Report: TAB Report
Function: Test, Adjust, & Balance
Date: 03/02/2026
Completed By: National TAB

**02-23-26 WHATABURGER #1644 GARNER,
NC**

Project Issue Information

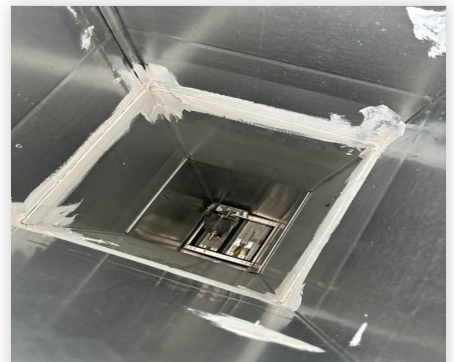
Issue Name : EF-1 Damper Not Opening
Description : The damper in the drop is not opening resulting in low flow for the two bathroom exhaust diffusers. The fan is set to the maximum speed, there are no odd shapes/angles in the duct work, and the branch dampers are 100% open. The damper in the drop needs to open in order for there to be appropriate flow.

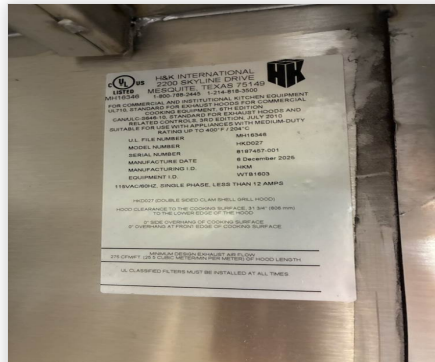
Issue Name : HD-1 Not Wired/Connected
Description : The on/off switch for HD-1 is not wired. The technician from Chisholm Service says the hoods are also not connected to the RTUs. The switch needs to be wired and the hood systems connected to the RTUs.

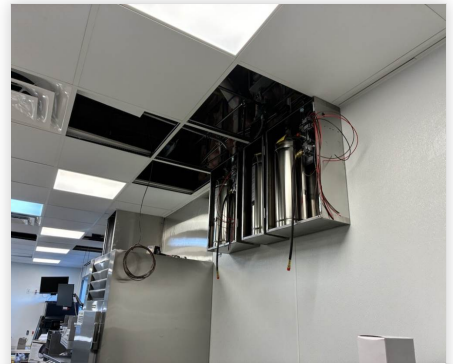
Issue Name : HD-2 Not Wired/Connected
Description : The on/off switch for HD-2 is not wired. The technician from Chisholm Service says the hoods are also not connected to the RTUs. The switch needs to be wired and the hood systems connected to the RTUs.
Created By : National TAB **Assigned To :** National TAB - Brianna Biggs
Status : Open
Priority : Urgent **Asset Tag :** HD2
Originated Date : 02/23/2026 - Alex Bauer - National TAB
